Referee #1 (Main)

Brief Communication: GIS-based liquefaction evaluation and risk assessment of facilities in Kimhae City, South Korea

Figure 4. Peak ground acceleration (PGA) vs. distance from epicenter

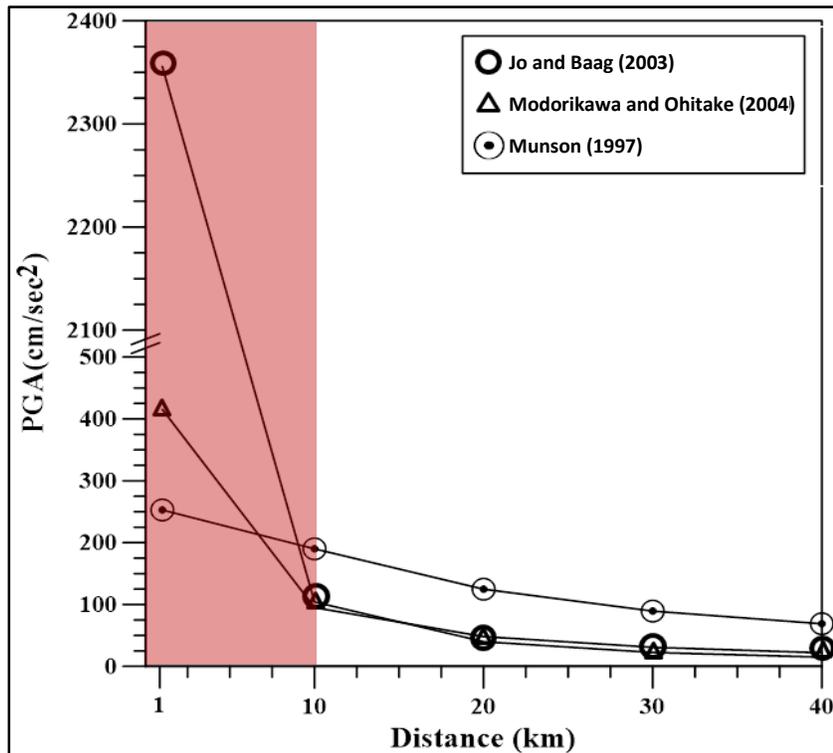
Referee's comments	Revised contents
<p>On page 7, lines 12 and 13, The text is hard to follow because there are many repetitions; Lines 152-3 say that "Choi et al. (2005) was used in this study", while lines 159-160 state the opposite for distance shorter than 10 km, and Table 3 (line 169) base the estimation on Jo and Baag (2003). Please rephrase and explain what were the attenuation relationships used in this study?</p>	<p>Choi et al. (2005) is replaced by Jo and Baag (2003). Jo and Baag (2003) is replaced by Choi et al. (2005) in Table 3.</p>

"from Munson (1997), with the latter being based on ground conditions in Hawaii. As the calculated values are shown in Figure 4, as there were no available data corresponding to a distance of less than 10 km and the attenuation relationship proposed by **Jo and Baag (2003)** resulted in the overprediction of the PGAs. Eqn. (12) expresses the attenuation relationship proposed by **Choi et al. (2005)**, and Table 3 describes the parameters of the attenuation relationship for estimating PGAs."

Figure 3. Distance from epicenter to the centroid of Kimhae City and Daedong-myeon, respectively.

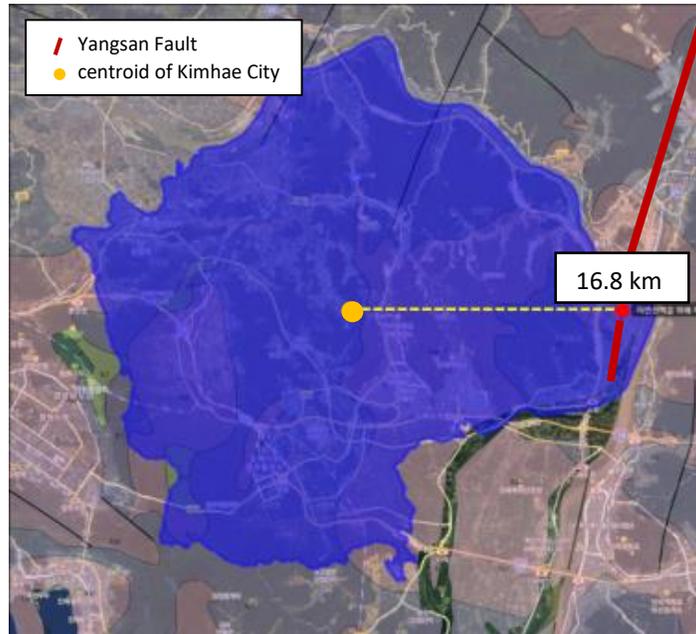
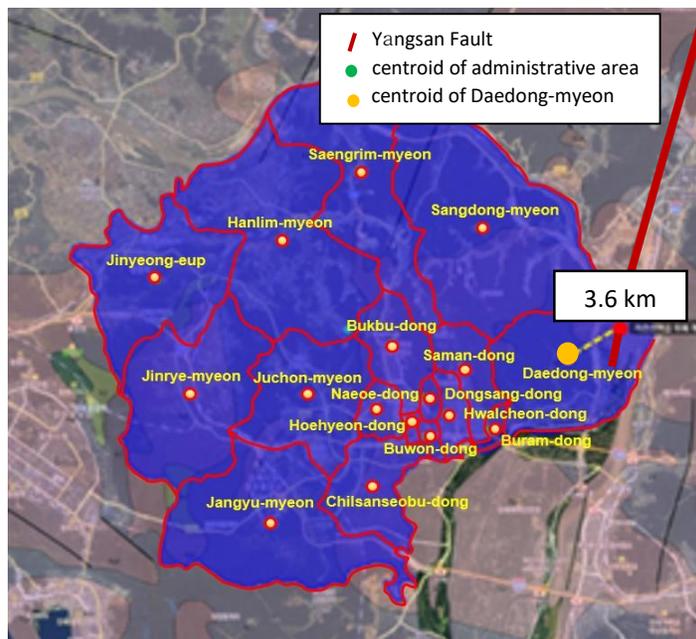
Referee's comments	Revised contents
<p>The text states: (lines 114-115): "the horizontally extended location from the centroid of Kimhae City to the closest fault is assumed to be the location of the epicenter". However, Figures 2a shows a line diagonal to the fault line rather than normal to it. The same should be applied for the 17 sub districts (Figure 2b). Thus there is a need to correct the distances and recalculate the expected PGAs.</p>	<p>The text states: (Lines 158-159): Figure 3a is correctly expressed how to determine the location of epicenter. Figure 3b shows the distance from the centroid of Daedong-myeon to the epicenter determined by Figure 3(a). Therefore, it is not necessary to recalculate PGA.</p>

Figure 2. Location of Kimhae City in South Korea

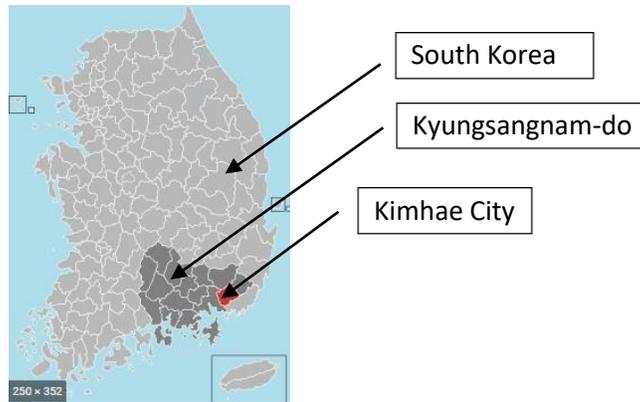
Referee's comments	Revised contents
<p>Figures There is a need to add location map of the study area and show where Kimhae City is in South Korea, the earthquake epicenters, faults and localities mentioned in the text.</p>	<p>Location map of the study area (Figure 2) is added.</p>

Figure 2 shows Kimhae City located in Kyungsangnam-do at the southern part of South Korea.

Figure 5. Location of standard penetration test (SPT) used to estimate LPI

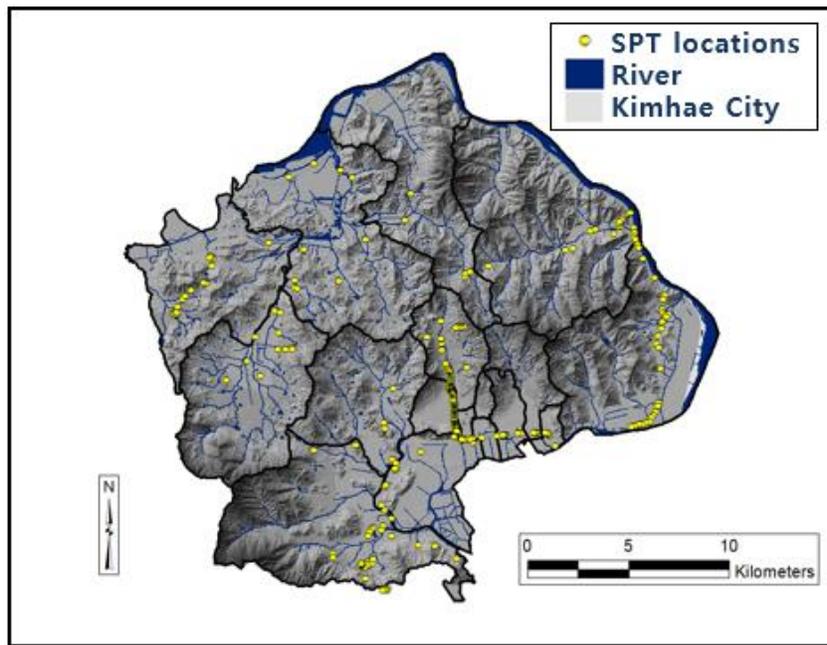
Referee's comments	Revised contents
<p>On page 6, Due to the poor resolution of map 4, it is not possible to identify the location of SPTs points and figure out the spread of SPT points across the city area. As far as I could see and understand, there are some areas with no data. The authors need to determine the threshold density of information relevant to the analysis, exclude no data areas from the analysis, and accordingly reexamine and modify the results presented and elaborated in Chapters 4 and 5 and in the relevant figures.</p>	<p>“The locations of SPT linearly arrayed inside of the dotted line may result in the deviation of contour lines of LPI as shown in Figure 4” are simplified to “The locations of SPT obtained in the roads are linearly arrayed as shown in Figure 5.”.</p> <p>Map 4 is magnified to be clearly viewed.</p>

Referee's comments	Revised contents
Line 175 "inside of the dotted line" – do you mean the dotted red ellipse in Figure 4?	Dotted red ellipse in Figure 5 is deleted because it is not necessary to be described.

The SPT data of 903 locations, provided by both the geotechnical information database system of a governmental organization and construction companies, were collected to estimate the LPI values in the study area. Since some of the important SPT data including ground depth and N-values were missing, a reliable dataset of 274 locations was selected, and then a GIS was used to plot the locations of the selected SPT data. **The locations of SPT obtained in the roads are linearly arrayed as shown in Figure 5.** The SPT data recorded at the various coordinates and the kriging method were used to construct the contour lines of the LPI values.

Figure 6. Spatial distribution of LPI for $M_w = 5.0$ and 6.5 earthquakes, respectively

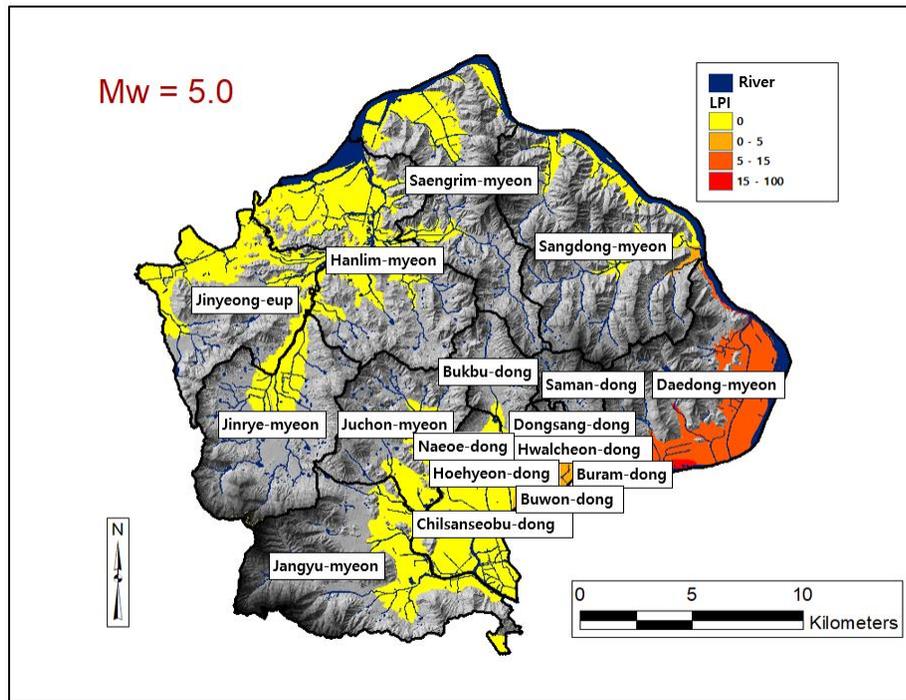
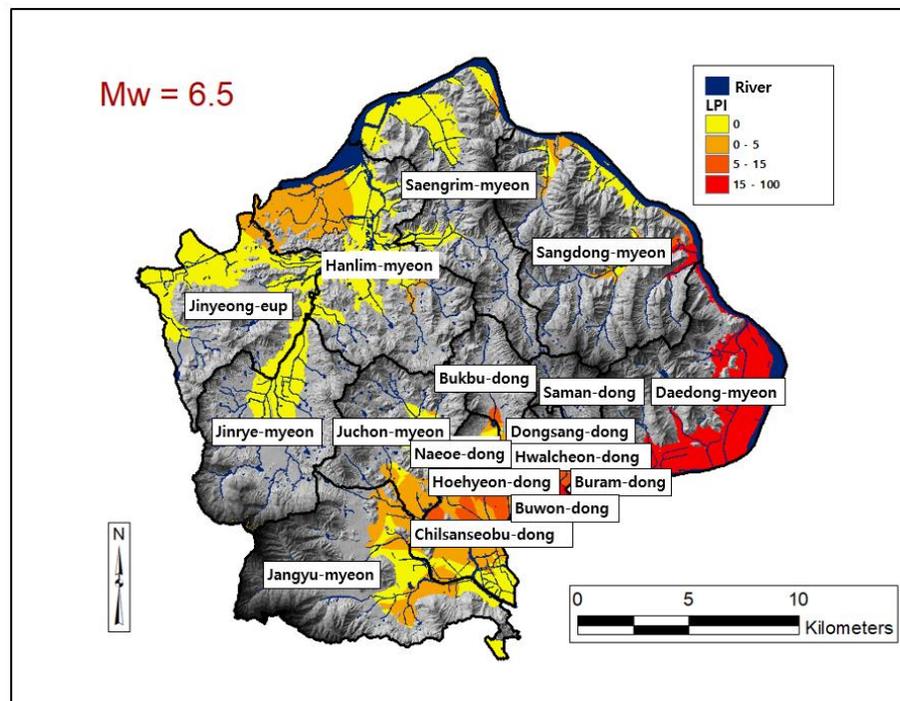
Referee's comments	Revised contents
<p>The maps are hard to read (I could hardly see the location of the SPTs points and other information), mainly due to low resolution and scale. Please improve resolution of the maps, text on the maps (Figures 5ab), size of legend, explain what is shown at the background of the maps, and show the limits of the urban area at the background.</p>	<p>Map (Figure 5) is magnified to be visible.</p> <p>The resolutions and size of legend for Figure 6ab are improved.</p> <p>Urban areas are described in the text but it is not appropriate to make the limits of the urban area in the figure.</p>

Algorithm using optimal GIS dimension developed by Jeon and O'Rourke (2005) and a kriging method has been used to determine LPI zones. Figures 6(a) and (b) show the LPI distribution and Figures 7(a) and (b) show the ratio of the covered area with respect to the range of the LPI values for $M_w = 5.0$ and 6.5 earthquakes, respectively. **Urban areas include Naeoe-dong, Hwalcheon-dong, Buwon-dong.**

Figure 1. Flowchart for estimating liquefaction potential index (LPI) (Choe and Ku, 2009)

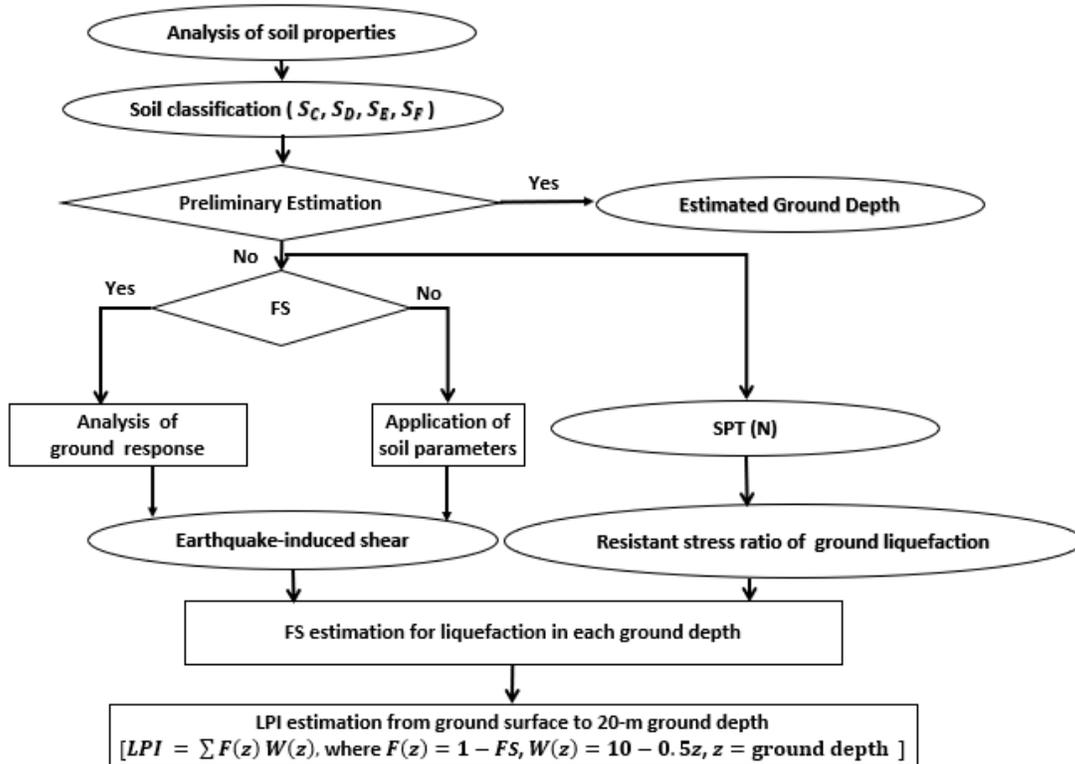
Referee's comments	Revised contents
<p>On page 6, What are the "Preliminary estimation" in the Flowchart (figure 1), and the criteria for 'yes' or 'no' decision? Similar question refers also to the criteria used for FS in the same flowchart. There is a need to present the soil classification used for the analysis.</p>	<p>Equations (2) - (9) are added to support Figure 1. Soil classification is added in the text.</p>

Referee's comments	Revised contents
The Authors adopted only Liquefaction Potential Index (LPI, originally proposed by Iwasaki et al. 1978, 1982), but more recent lumped parameters have been proposed (e.g. Liquefaction Severity Number, LSN, etc.) and widely used in the literature.	Since SPT N-values are available in this study area, LPI is used for the analysis. Unfortunately, there are no CPT results for LSN.
Many sentences in the manuscript need to be substantiated by citing bibliographic references from the literature, e.g. available methods for assessing liquefaction potential from SPT, CPT, etc. I strongly recommend to adopt more than one method available for SPT data.	Since SPT N-values are available in this study area, LPI is used for the analysis. Unfortunately, there are no CPT results for LSN.
All the steps of the methodology are not clear in the current version of the flowchart (Figure 1), that needs to be improved, in my opinion. Please, check carefully any missing arrows and consequent step/s.	The flowchart (Figure 1) is revised to be visible and explained in details with equations as shown in previous page.

A simplified method for estimating the FS of liquefaction was proposed by Idriss and Boulanger (2010), as follows:

“In this study, the LPI proposed by Iwasaki et al. (1978) was used to estimate the ground damage level induced by liquefaction. As described in Eqn. (1), the LPI is calculated based on the ground depth and characteristics of soil such as S_c (very dense soil and soft rock), S_d (stiff soil), S_e (soft soil), and S_f (soil requiring site-specific evaluation), as follows:”

Figure 2. Location of Kimhae City in South Korea

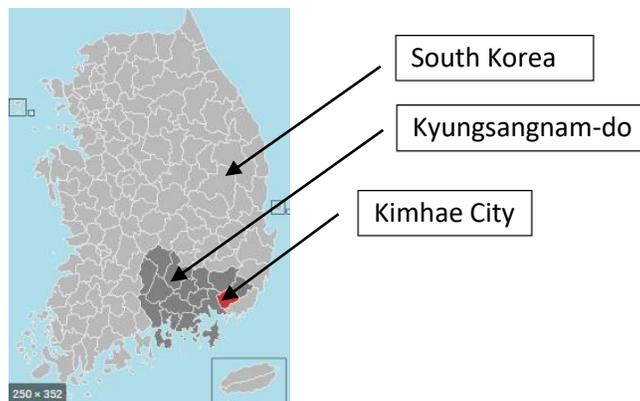
Referee's comments	Revised contents
<p>Line 35 Since the study is going to be published in an international journal, a figure introducing the study area in the geographical context of South Korea will be greatly appreciated;</p>	<p>Figure 2 is added to specify the relative location of the study area in South Korea.</p>

Figure 2 shows Kimhae City located in Kyungsangnam-do at the southern part of South Korea.

Figure 3. Distance from epicenter to the centroid of Kimhae City and Daedong-myeon, respectively.

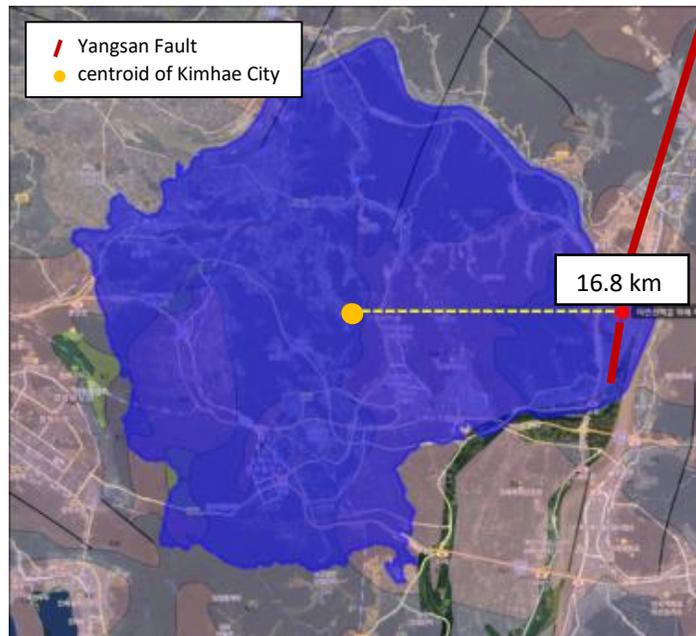
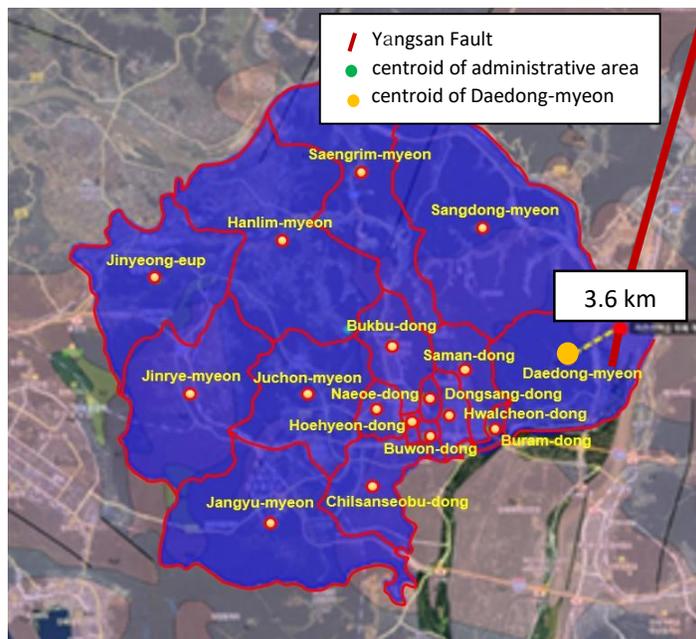
Referee's comments	Revised contents
Figure 2b. The centroids of the administrative areas are not visible. Please, move the centroid layer above the shaded area of study;	Figure 3b is modified to be visible.
Table 2. The administrative districts are listed in Table but cannot be visualized in Figure 2. Please, rearrange the map in Figure 2a so that the name and boundary of each district can be identified;	Figure 3b is modified to identify the name and boundary of each district.

Figure 4. Peak ground acceleration (PGA) vs. distance from epicenter

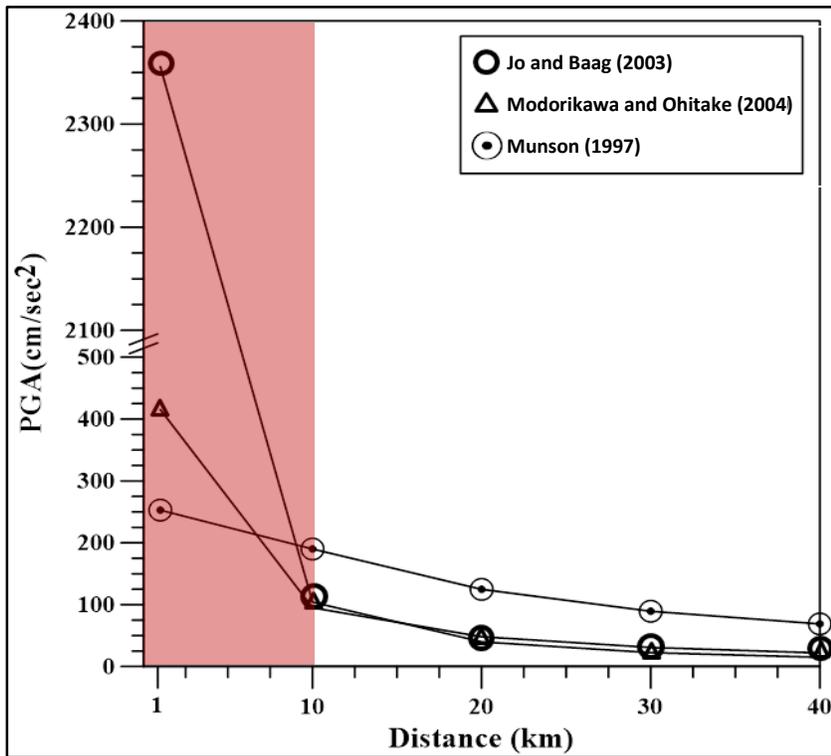
Referee's comments	Revised contents
Figure 3. Labels in the legend cannot be read. Please, increase the figure resolution. However, the law by Choi et al. (2005) seems not reported, differently from what is said in the text. Please, revise accordingly;	Labels in the legend is modified and the figure is enlarged to be clearly visible. Choi et al. (2005) is replaced by Jo and Baag (2003). Jo and Baag (2003) is replaced by Choi et al. (2005) in Table 3.

“from Munson (1997), with the latter being based on ground conditions in Hawaii. As the calculated values are shown in Figure 4, as there were no available data corresponding to a distance of less than 10 km and the attenuation relationship proposed by **Jo and Baag (2003)** resulted in the overprediction of the PGAs. Eqn. (12) expresses the attenuation relationship proposed by **Choi et al. (2005)**, and Table 3 describes the parameters of the attenuation relationship for estimating PGAs.”

Figure 5. Location of standard penetration test (SPT) used to estimate LPI

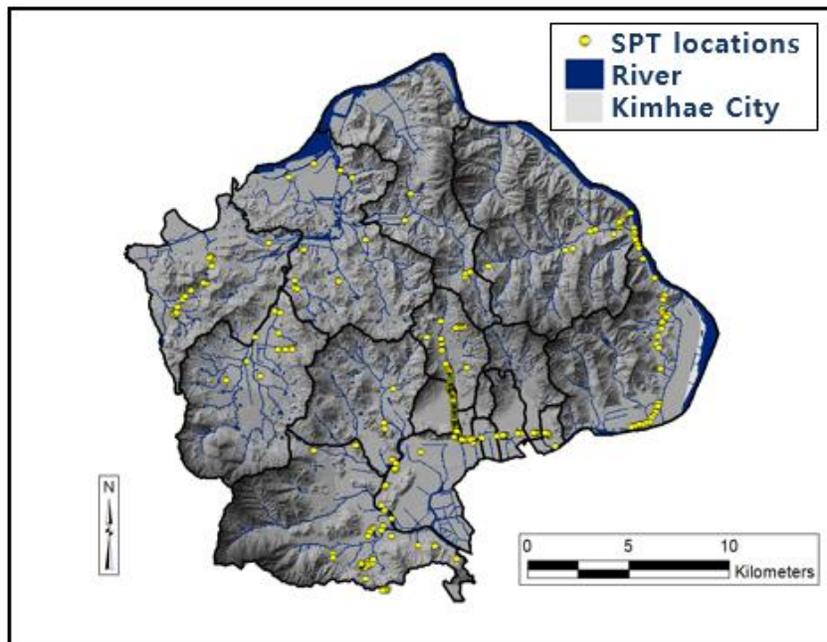
Referee's comments	Revised contents
Figure 4. It is too small and the legend is unreadable. Please, enlarge the figure and increase the resolution;	Figure 5. The figure is enlarged and the legend is modified with high resolution.
